PROJECT: 3090 Zone North Interim Trak

CITY OF LAS VEGAS INTER-OFFICE MEMORANDUM			DATE: January 3, 2017		
TO: Land Development Services Department of Building & Safety			FROM: Albert Sung, P.E.  Flood Control Project Engineer Department of Public Works		
SUBJECT: Drainage Study for: 3090 Zone North Interim Tank			COPIES TO: Slater Hanifan Group Ninety-Five Management, LLC Bart Anderson, P.E., DevCo		
Cross Streets:	NWC of Centennial Parkway and Puli Road				
File Number:	F:\Depot\DSMemos\DS4854A.doc				
Parcel Number:	126-23-000-001				
Zoning Action:	SDR-xxxxx				
FEMA Flood Zone	YES	NO			
Proposed Storm Drain	YES	NO	X

The Drainage Study for the subject project has been reviewed and:

is approved subject to conformance to all City standards and the following conditions:
X	must be resubmitted or supplemented including the following:
	is conditionally approved subject to Clark County Regional Flood Control District concurrence.
	is conditionally approved subject to Clark County Public Works Department concurrence.

GRADING PLAN

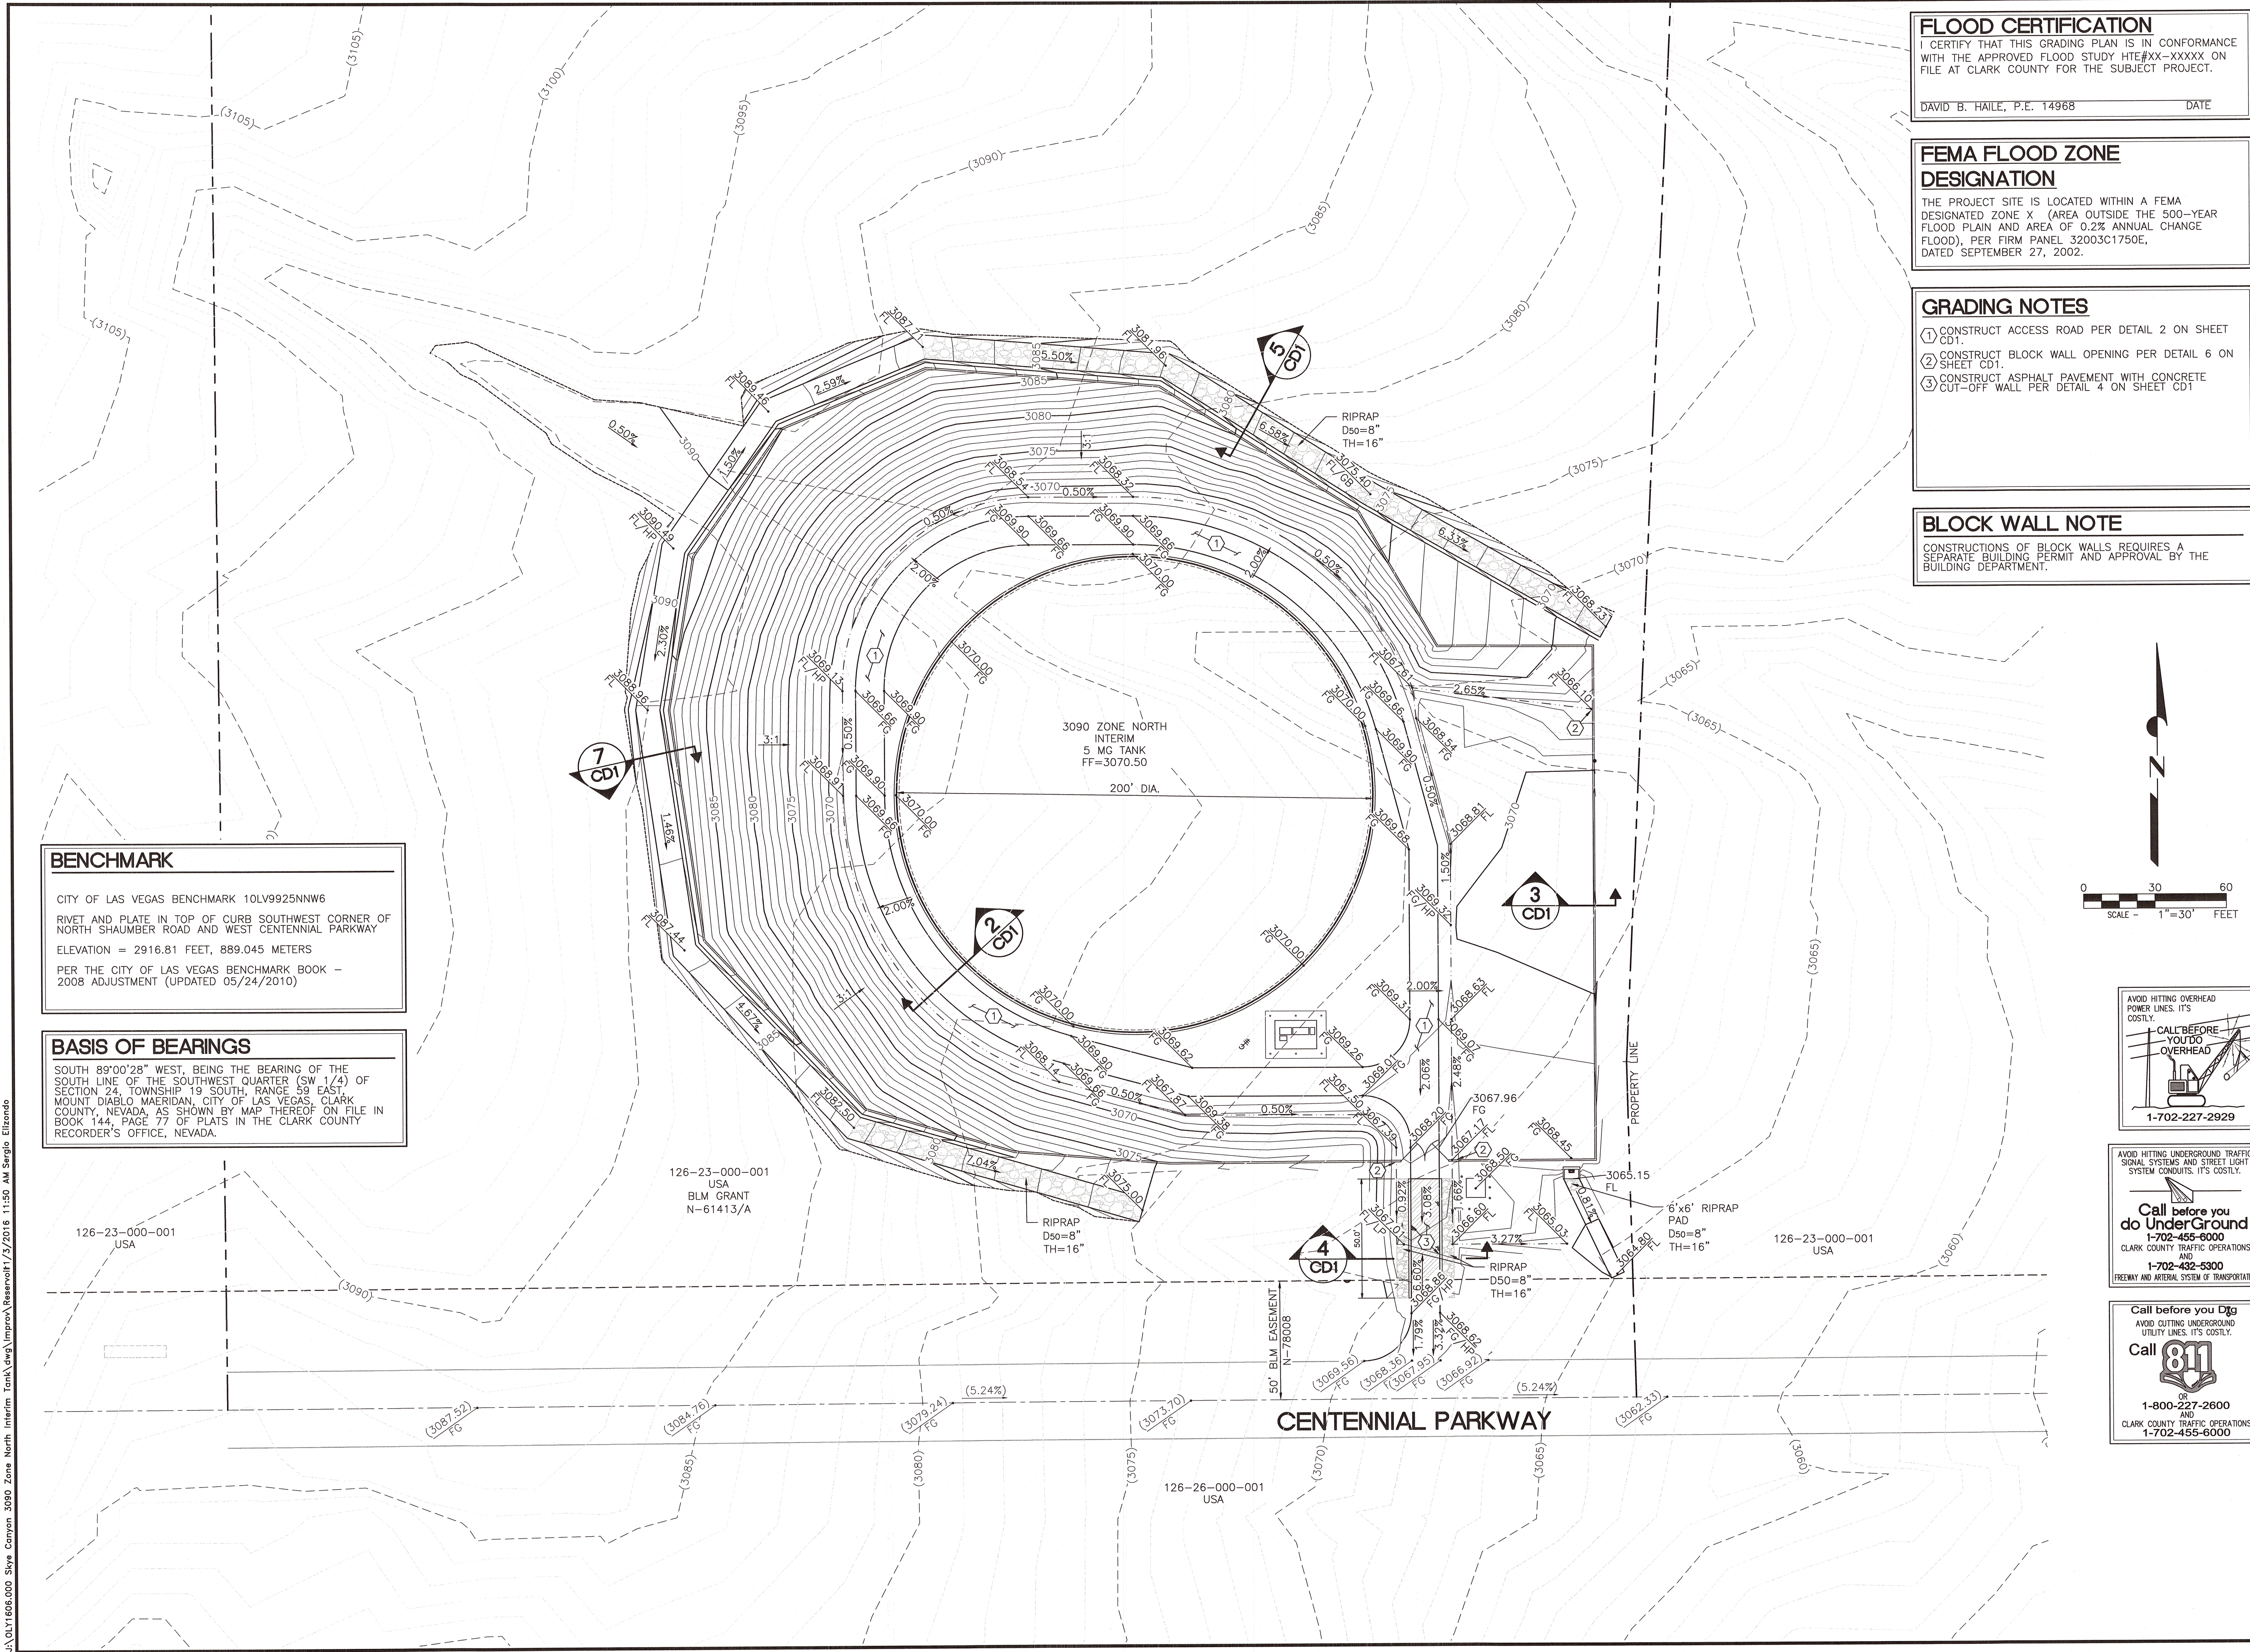
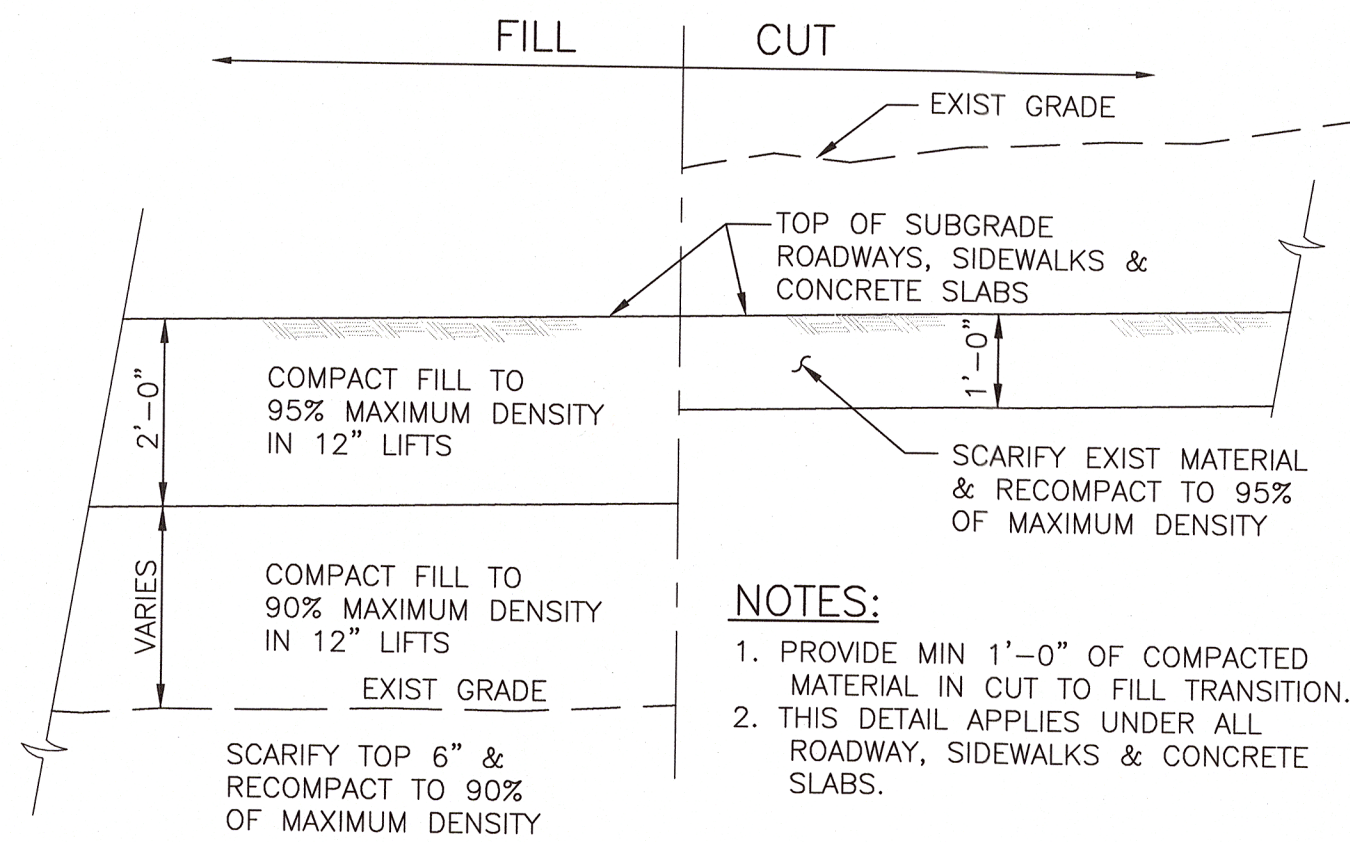
1. The proposed water reservoir outfall/discharge pipe is not connected to the permanent storm drain facility. Please connect the outfall pipe to the existing storm drain facility in Centennial Parkway at Puli Road alignment.
2. Please coordinate with Greg McDermott with City of Las Vegas Roadway Planning Department at 702-229-2143 regarding the location of the reservoir and outfall pipe.

1. While the vicinity map shows the tank location offset from the east property line of parcel 126-23-000-001, no specific dimensions are provided to what is assumed to be a BLM easement line, currently labeled as "Property Line" on the grading plan. Exhibit E shows the existing Gowan Channel approximately 380 feet from the project site; provide that information and the distance to the east property line on the grading plan.
2. Any improvements not depicted on the above mentioned grading plans may require an Update to this Technical Drainage Study.
